# Access Compliance Report

## Public Rights-of-Way

Intersection ID: 50665	Main Street: SAMUEL_NEEL_RD	Cross Street: COVE_POINT_DR	Location: NW
ADA ID: D2560ABADB33	Ramp Type: PerpDiag	Initial Pass/Fail: Fail	Overall Compliance: No
Severity Score: 12.5			
Codes/Mitigation Info/Possible Solution		Field Measurements/Component Compliance

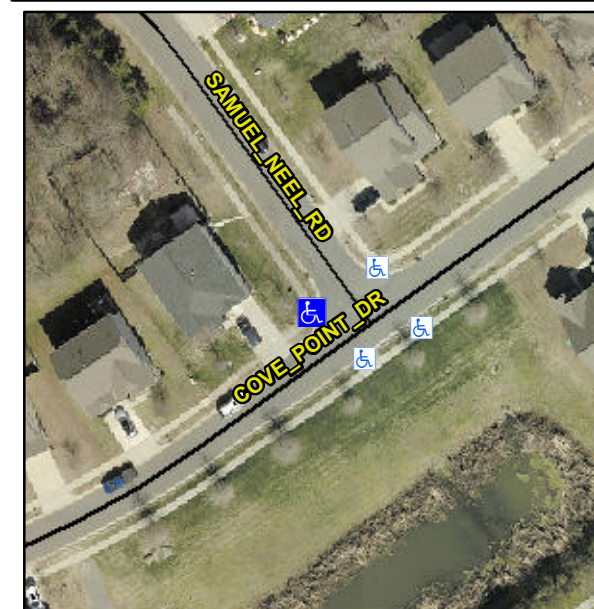
Possible Solutions:

**Remove & Replace Curb Ramp With Two New Directional Ramps or Equivalent.**

**R304.2.2**

Compliance	Description	Data	Compliance	Description	Data
N/A	Ramp Length (in)	47.0	No	Ramp Slope (%)	11.2
Yes	Ramp Width (in)	48.0	Yes	Ramp XSlope (%)	1.2
N/A	Flare Type LT	N/A	N/A	Flare Type RT	N/A
N/A	Flare Slope LT (%)	N/A	N/A	Flare Slope RT (%)	N/A
N/A	Flare Traversable LT?	N/A	N/A	Flare Traversable RT?	N/A
N/A	Landing Length (in)	N/A	N/A	DWS Provided?	N/A
N/A	Landing Width (in)	N/A	N/A	DWS Contrast?	N/A
N/A	Landing Slope (%)	N/A	N/A	DWS Length (in)	N/A
N/A	Landing X Slope (%)	N/A	N/A	DWS Full Width?	N/A
N/A	Landing Curb? (Y/N)	N/A	N/A	DWS Offset (in)	N/A
N/A	Shared Landing?	N/A			
N/A	Gutter Ponding?	N/A	N/A	Gutter Slope (%)	N/A
N/A	Gutter Lip Ht (in)	N/A	N/A	Gutter X Slope (%)	N/A
N/A	Painted X Walk1?	No	N/A	Painted X Walk2?	No
	X Walk 1 Direction	To SE		X Walk 2 Direction	To NE
N/A	X Walk 1 Width (in)	N/A	N/A	X Walk 2 Width (in)	N/A
	X Walk 1 Slope (%)	0.2		X Walk 2 Slope (%)	1.5
	X Walk 1 X Slope (%)	0.1		X Walk 2 X Slope (%)	1.4
